APPENDIX E: Traffic Analysis

Canyon Hills Manor ■ Draft Environmental Impact Report

Re: Draft Environmental Impact Report on Canyon Hills Manor

Subject: Canyon Hills Manor Draft EIR – Traffic Section

FIGURE 2

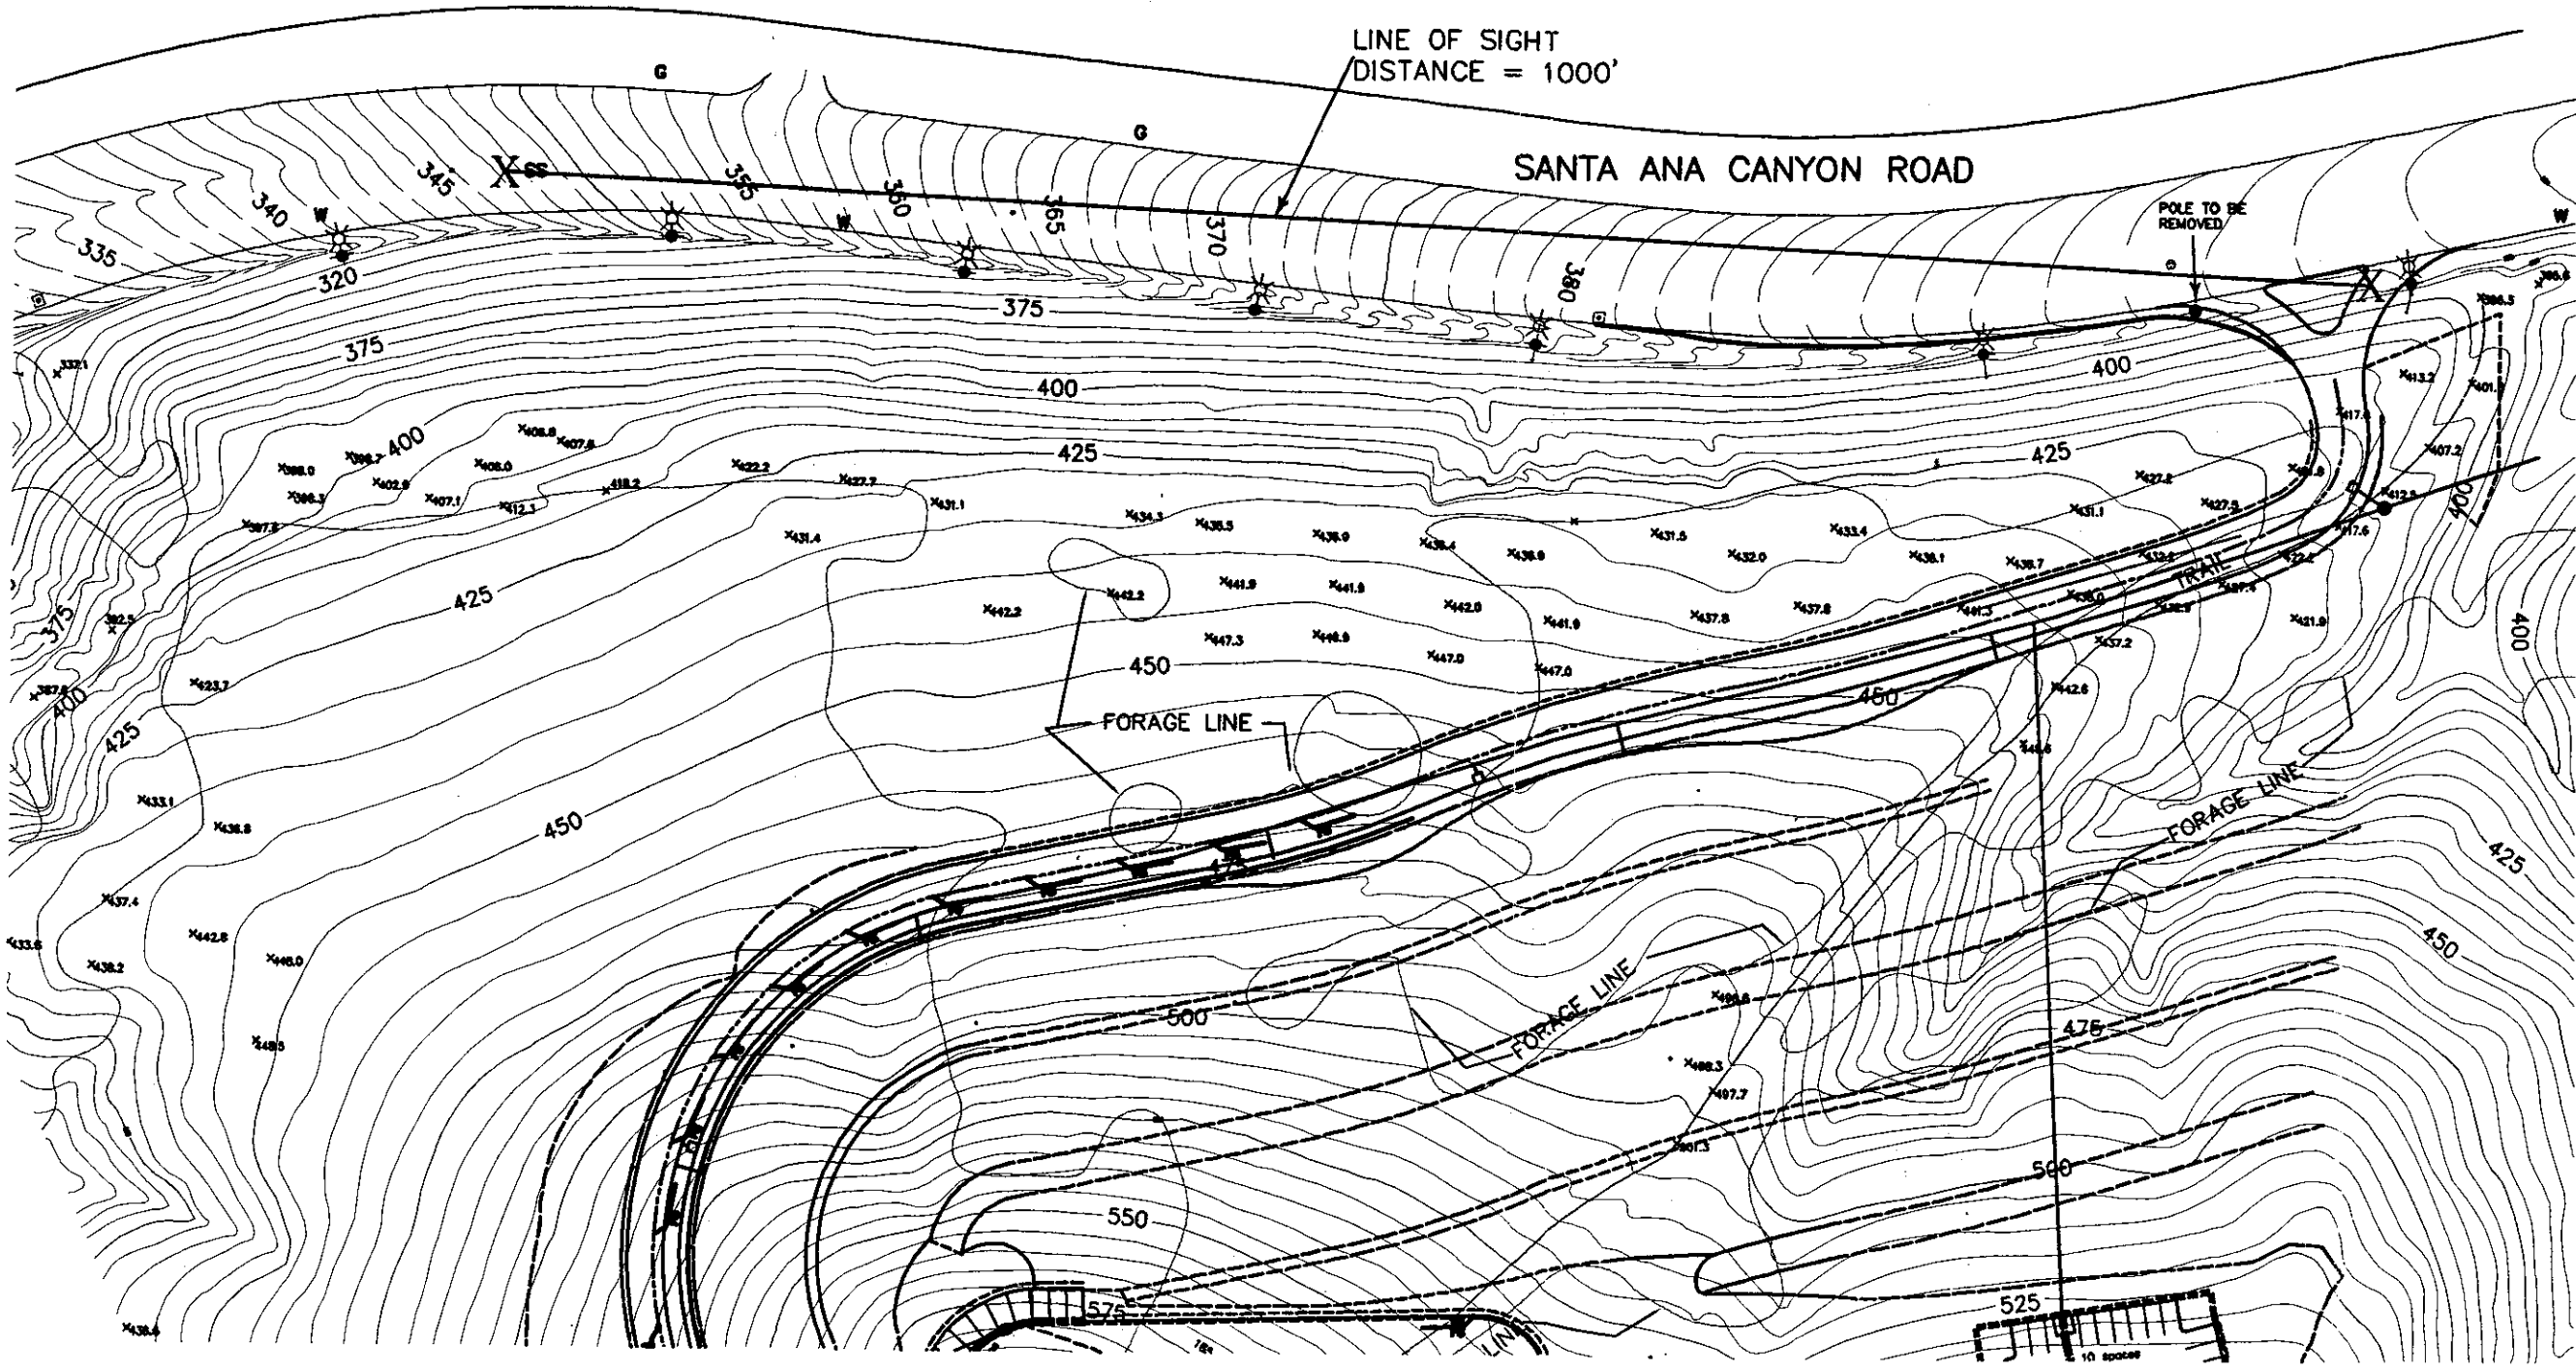
The sight distance for drivers exiting the site was examined using the site-grading plan. A driver located 10 feet behind the end of the driveway at Santa Ana Canyon Road can see eastbound vehicles approaching for a distance of 1,000 feet (See Figure 2). Based upon **Table 201.1** of the Caltrans "Highway Design Manual", a speed of 80 km/hr (50 MPH) requires a stopping sight distance of 130m (425 ft.). On this basis, the sight distance would be more than adequate.
